# CRMC DECISION WORKSHEET

2017-12-040

Narragansett Electric Co. d/b/a National Grid

**STATE OF RHODE ISLAND AND PROVIDENCE PLANTATIONS  
COASTAL RESOURCES MANAGEMENT COUNCIL  
STAFF ENGINEER'S REPORT**

DRAWING:	S-5
		SHEET NO.:	31 OF 31

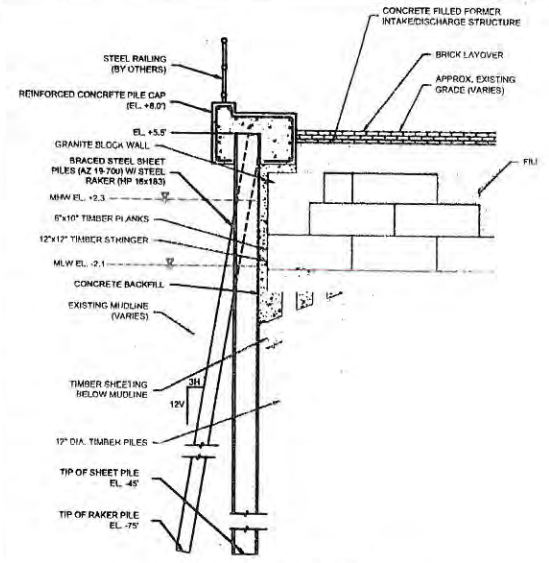
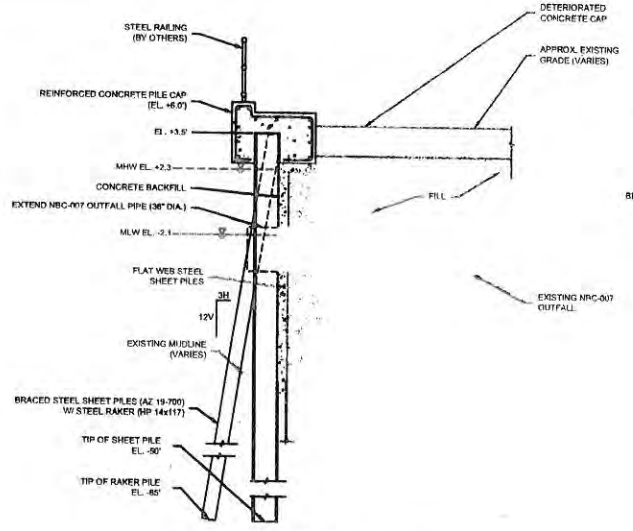
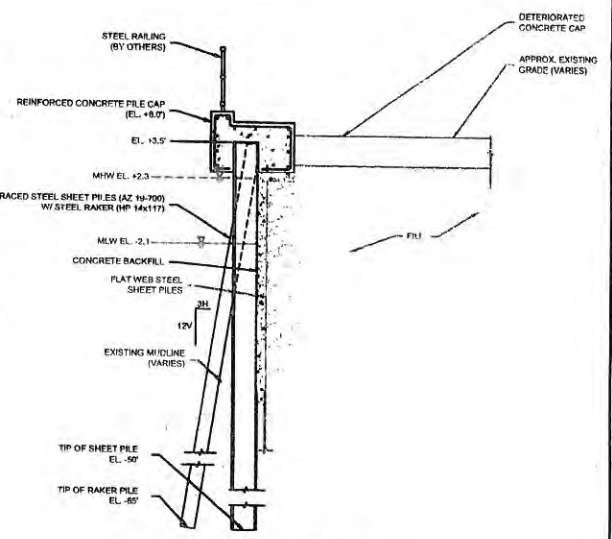
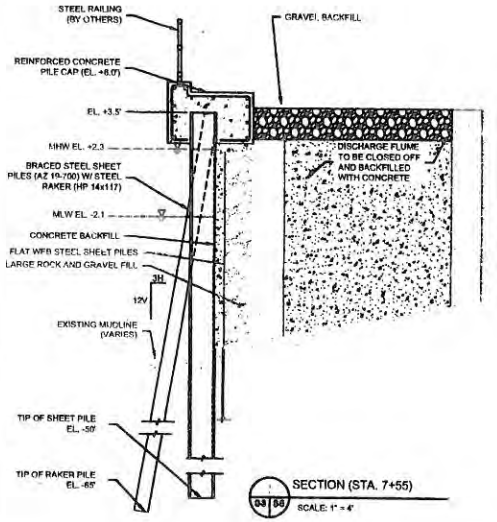
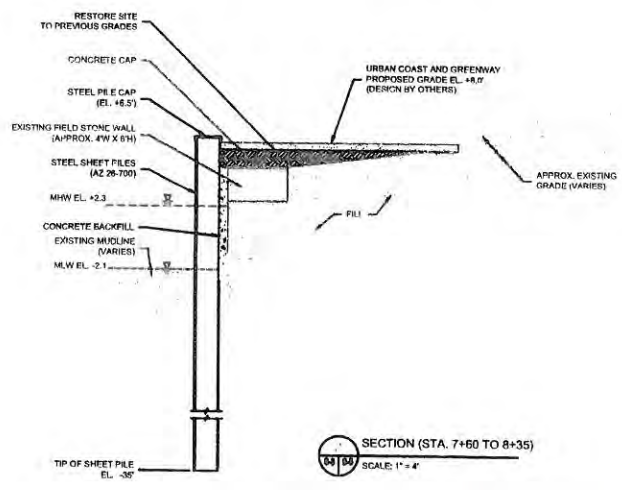
- Sections 2+80 to 7+64 due to site conditions (height of wall, soil conditions and higher expected loads) the proposed sheet pile wall be braced with a “raker” (steel batter H-piles) system that extend into tidal waters in lieu of a cantilevered wall. Please note that typically a tieback/deadmen system is installed for walls that cannot be cantilevered. This structural support system is required because deadmen or tiebacks cannot be installed because of the extent of buried structures behind the wall (utilities and foundations). Additionally, from Section 5+45 to 7+60 a concrete cap will be installed to facilitate public access to the waterfront.

The sheetpiles will be installed as close as practicable as site conditions allow however, there is an expected encroachment of 2 to 2.5 feet from the existing seawall face. The encroachment is based on a 20-inch wide sheet pile wall with an additional 4-6 inch construction tolerance. The “raker” piles will be installed outboard of the new sheetpile wall and will intersect the mudline in the Providence River at approximately 3.9 to 5.1 feet from the face of the new sheetpile wall.

A braced steel sheet pile wall is necessary to structurally support the proposed UCG. Conventional bracing systems such as tiebacks or a deadman system are unable to be constructed within the upland areas due to the existing buried structures, foundations, and utilities behind the existing seawalls. As a result, a “raker” (steel batter H-piles) system is proposed to support the bulkhead outboard of the new sheet pile wall. Consistent with CRMP Section 300.7.F.1, the sheet pile wall will be installed as close to the existing walls as practicable (as close as existing conditions allow) and anticipated to extend approximately 2 to 2.25 feet from the existing seawall face. This encroachment is based on a 20-inch wide sheet pile wall with an additional 4-to 6-inch offset to allow piles to be driven straight and plumb. The “raker” piles will be installed outboard of the new sheet pile wall at a 3:12 batter. When measured at the mudline, the “raker” pile will encroach into the Providence River approximately 5.1 feet from the face of the new sheet pile wall. The proposed wall system will prevent additional erosion from occurring behind the deteriorated wall sections. Refer to Figures S-4 and S-5 – Sections D through F for details of the wall system.

Similar to Wall Section 2, this wall section requires the use a steel sheet pile coupled with “raker” piles to provide sufficient support of the proposed UCG due to the large exposed wall heights and poor soil conditions. The sheet pile wall will be installed as close to the existing walls as conditions allow and are anticipated to encroach into the Providence River approximately 2 to 2.25 feet from the existing seawall face. This encroachment is based on a 20-inch wide sheet pile wall with an additional 4 to 6-inch offset to allow piles to be driven straight and plumb. The “raker” piles will be installed

outboard of the new sheet pile wall at a 3:12 batter. When measured at the mudline, the “raker” pile will encroach into the Providence River approximately 3.9 feet from the face of the new sheet pile wall. The new sheet piles will also prevent further material loss occurring behind the existing structure while preserving a similar facade.

A concrete cap will be installed at the top of the sheet pile wall along this wall section to facilitate public pedestrian access to the waterfront. The concrete cap will partially extend out over the top of the sheet pile wall and “raker” piles. This concrete cap will limit visual appearance of the wall system above the water line (i.e., partially obstruct view of “raker” piles), enhance waterfront accessibility, and minimize potential interference of public fishing activities. Refer to Figure S-5 – Sections G through I for details of the wall system.

DETAIL - (STA. 8+35 TO 10+57)  
SCALE: 1" = 4'

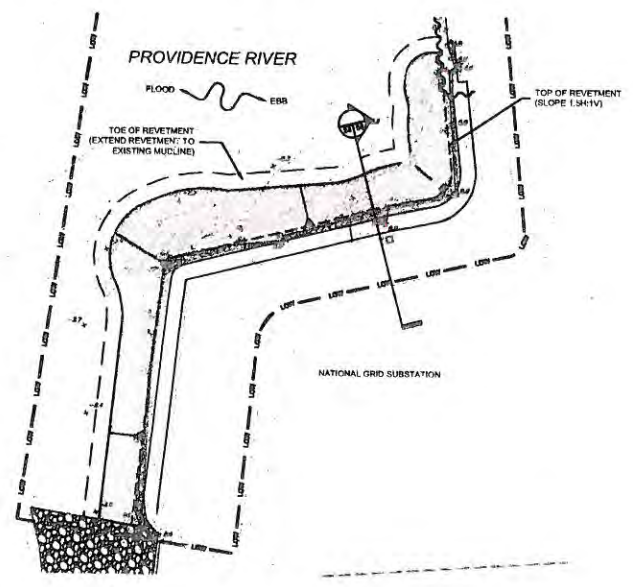
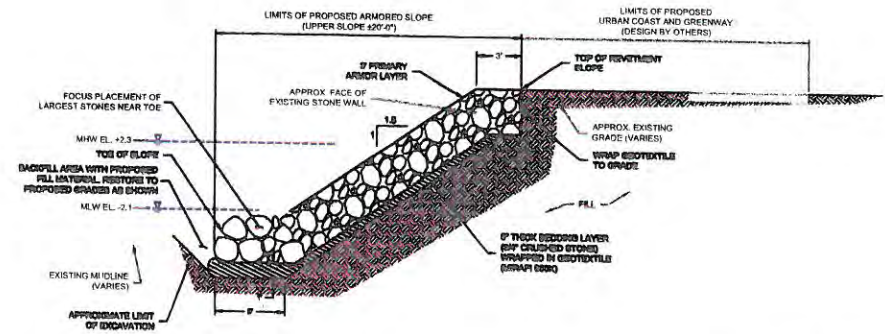
The proposed riprap revetment will extend beyond the current footprint of the existing seawall to accommodate the width of the upland UCG and provide a walking path. The area where the riprap revetment extends 15-20 feet beyond the existing seawall has little navigational impact and is the location of a NBC combined sewer overflow outfall. As stated in the applicants report “Without this extension, the width of the UCG (paved path and vegetated areas) along the Site would need to be reduced and would not meet the requirements of the CRMC’s Urban Coastal Greenway Policy for the Metro Bay Region.” Based on the above there are no engineering objection to the proposed revetment.

The proposed rip rap revetment restores the existing seawalls’ appearance while providing erosion control and structural support for the proposed UCG. Construction of a rip rap revetment would be more economical than constructing a sheet pile wall and will not require any alignment modifications to the UCG. Based on conversations with BETA Group, Inc. and review of the final permit drawings, a timber pedestrian bridge is proposed to span across water inlet at approximately Station 9+75. The 1.5H:1V riprap revetment will extend beyond the pedestrian bridge timber abutment pilings and tie into the NBC Outfall No. OF-008 concrete wall. Rip rap at this location will be similar to that of the existing riprap slope at Outfall No. OF-008. Refer to Figure S-6 – Sections K and L.

DETAIL - STONE REVETMENT/HABITAT RESTORATION LAYER LAYOUT (STA. 8+35 TO 10+37)  
SCALE 1"=20'

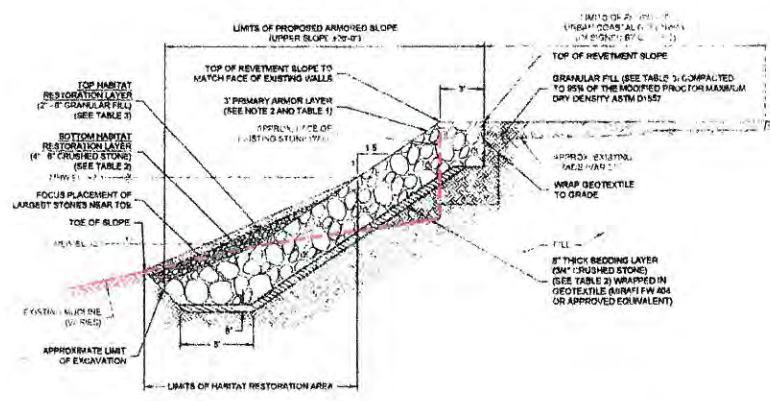
The ideas and recommendations offered by Ms. Verkade (National Marine Fisheries Service) to mitigate the loss of potential habitat were extremely useful. We believe a mitigation plan that restores potential habitat areas can be accommodated. Ms. Verkade indicated that the impacts associated with the steel sheet pile section of the seawall along the south side of the project Site will not require mitigation. The proposed steel sheet pile seawall is being placed as close as practicable to the existing dilapidated seawall. The footprint of the steel sheet pile wall is approximately 2,730 square feet along approximately 850 linear feet of the seawall.

Along the northern end of the project Site within the Ship Street Inlet area, the proposed steel sheet pile seawall will transition into a riprap embankment. The footprint of the riprap revetment is approximately 3,280 square feet along approximately 200 linear feet of the seawall. This portion of the proposed seawall will be altered to mitigate impacts to potential EFH. The portion of the riprap embankment that is below mean high water will be top dressed with a layer of small round stones and granular fill underlain by a supportive crushed stone layer. The goal of this restoration layer is to provide habitat that will mimic the lost riverbed area and provide a foundation that will support the growth of submerged aquatic vegetation. The layer will also provide conditions suitable to Winter Skate, Cod, Winter Flounder, and other marine species found in the Providence River and Narragansett Bay. Approximately 2,550 square feet of area will be restored to provide habitat restoration. We have attached a drawing that provides a plan view and cross section of the habitat restoration layer. The slope of the habitat layer was designed to minimize additional impacts to the Providence River.

1. Loss of Essential Fish Habitat will be mitigated for according the enclosed plan entitled "SOUTH STREET SUBSTATION PROVIDENCE, RHODE ISLAND SEAWALL REPLACEMENT STONE REVETMENT/HABITAT RESTORATION LAYER LAYOUT AND SECTION", in one sheet dated "MAY 2018".
2. The turbidity curtain shall be removed upon completion of work. Sediment and debris collected by this device shall be removed and placed at an upland location in a manner that will prevent its later erosion into a waterway or wetland.
3. Pile driving shall be performed using a vibratory hammer. A slow start technique shall be utilized during the driving of piles to ensure that any mobile marine species in the project impact area have time to leave the project site prior to injury inducing noise levels are reached.
